Changes for PJM Manual 21A

Determination of Accredited UCAP Using Effective Load Carrying Capability Analysis

Markets & Reliability Committee

April 27, 2022

“Section 5.2.1 Onshore Wind and Solar

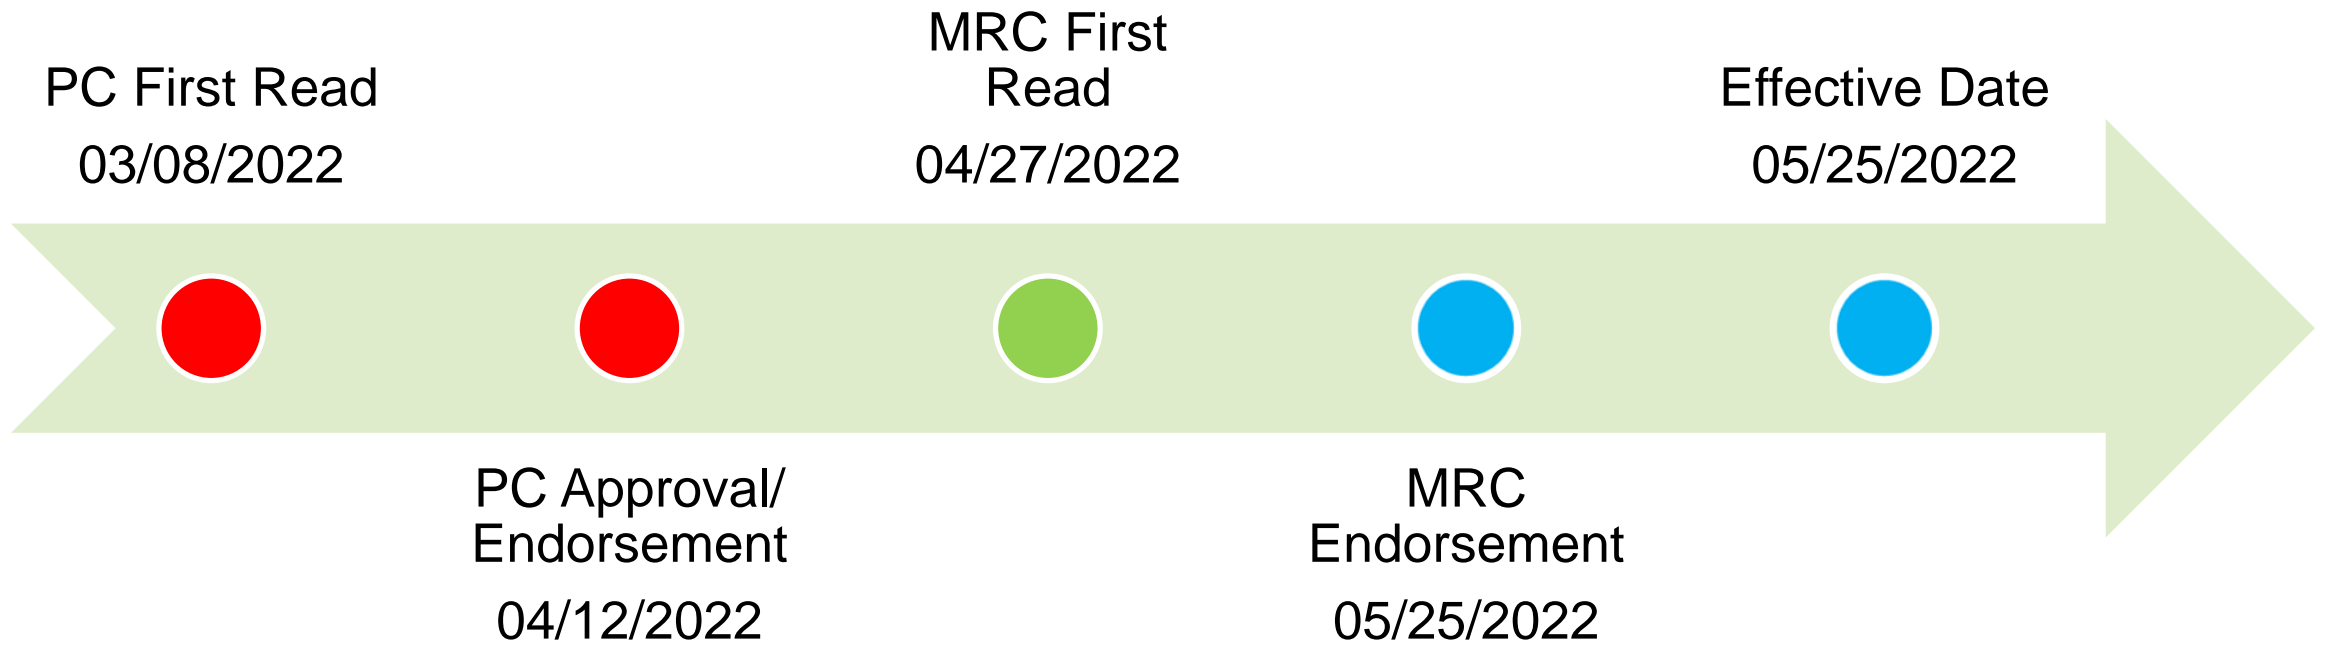
Remove language to allow the current voluntary process to continue beyond March 1, 2022:

~~Starting with ELCC data submission on or after March 1, 2022, providers of onshore wind and solar resources must provide the following data. Prior to March 1, 2022, providers~~
Providers of onshore wind and solar resources must provide the following data only if requesting a unit-specific backcast, otherwise they may provide it if desired.”
